Contract No. EP/SP/66/12
Integrated Waste Management Facilities, Phase 1
Proposal for Relocating Marine Water Quality Monitoring Station F1 (Rev. B)

Proposal for Relocating Marine Water Quality Monitoring Station F1

KSZHJV	/	312	/		/	0001	/	B
Issuer		Project Code		Type of Document		Sequential No.		Revision Index

Figure 1 – Location of marine water monitoring location of F1 (existing) and F1A (newly proposed) for Cheung Sha Wan fish culture zone

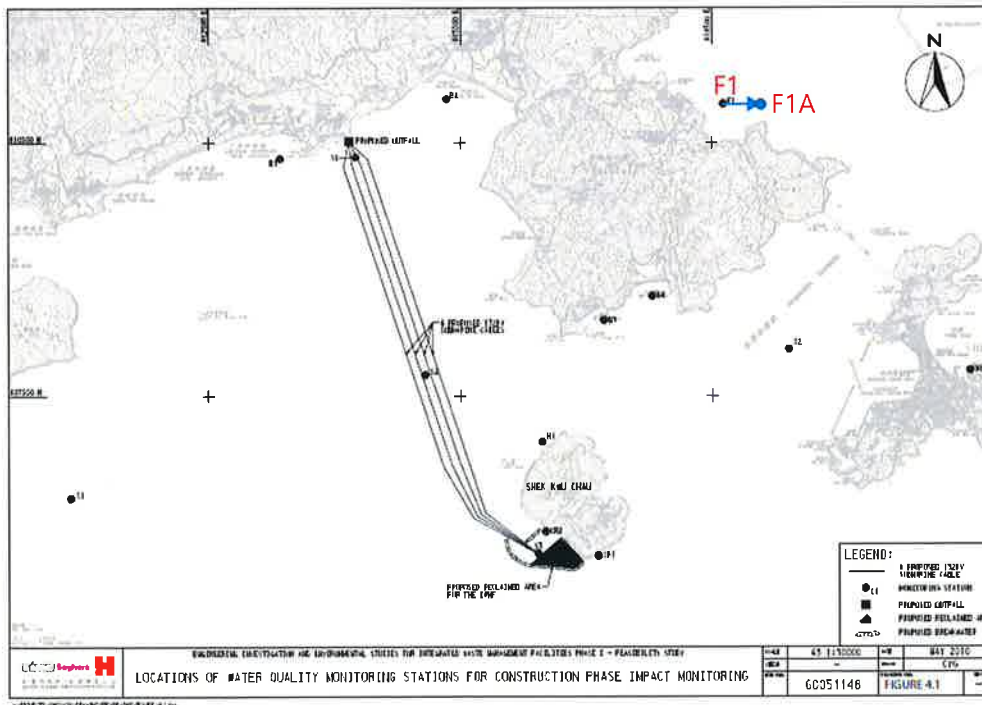
As such and pursuant to Condition 3.1 of the Environmental Permit and 4.3.1 paragraph of EM&A Manual, it is thus proposed to relocate the F1 water monitoring location to a new location to be named as F1A. as shown in Figure 1 for verification by IEC and approval by EPD.

Figure 10 – Distance between F1 and F1A is about 450m

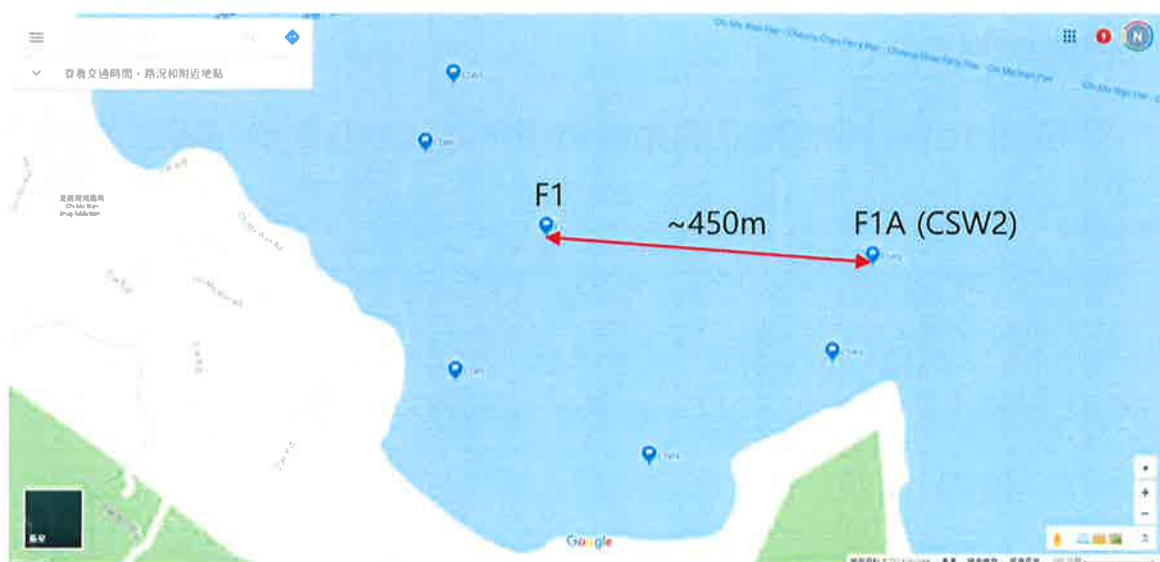
This new monitoring station will be named as F1A with the following coordinates, the close proximity between F1 and F1A is also shown in Figure 10.

Monitoring Stations	Northing	Easting
F1	810966	818631
F1A	810924	819109
